# Access Compliance Report

## Public Rights-of-Way

### (Curb Ramps)

Intersection ID: 1002095	Main Street: J_W_CLAY_BV	Cross Street: N/A	Location:	E
ADA ID: FD7340B86620	Ramp Type: Perp	Initial Pass/Fail: Fail	Overall Compliance: No	Severity Score: 35

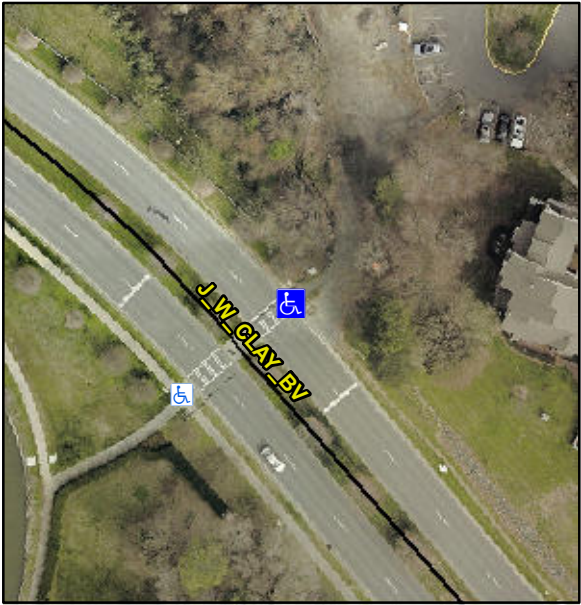
Codes/Mitigation Info/Possible Solution			Field Measurements/Component Compliance		
	Possible Solutions:		<b>Compliance</b>	<b>Description</b>	<b>Data</b>
	<b>Remove &amp; Replace Entire Ramp.</b>		<b>No</b>	Ramp Length (in)	30.0
			<b>No</b>	Ramp Width (in)	36.0
			<b>N/A</b>	Flare Type LT	N/A
			<b>N/A</b>	Flare Slope LT (%)	N/A
			<b>N/A</b>	Flare Traversable LT?	N/A
			<b>N/A</b>	Landing Length (in)	N/A
			<b>N/A</b>	Landing Width (in)	N/A
			<b>N/A</b>	Landing Slope (%)	N/A
			<b>N/A</b>	Landing X Slope (%)	N/A
<p>Surveyor Notes:</p> <p><b>N/A</b></p>			<b>N/A</b>	Landing Curb? (Y/N)	N/A
			<b>N/A</b>	Shared Landing?	N/A
			<b>N/A</b>	Gutter Ponding?	N/A
			<b>N/A</b>	Gutter Lip Ht (in)	N/A
			<b>N/A</b>	Painted X Walk1?	Yes
				X Walk 1 Direction	To W
			<b>N/A</b>	X Walk 1 Width (in)	110.0
				X Walk 1 Slope (%)	2.8
				X Walk 1 X Slope (%)	3.2
			<b>N/A</b>	Ramp inside XWalk1?	Yes
<p>PROW/ADA:</p> <p><b>R304.5.1, R304.2.2, R304.5.3</b></p>			<b>N/A</b>	Road Slope (%)	N/A
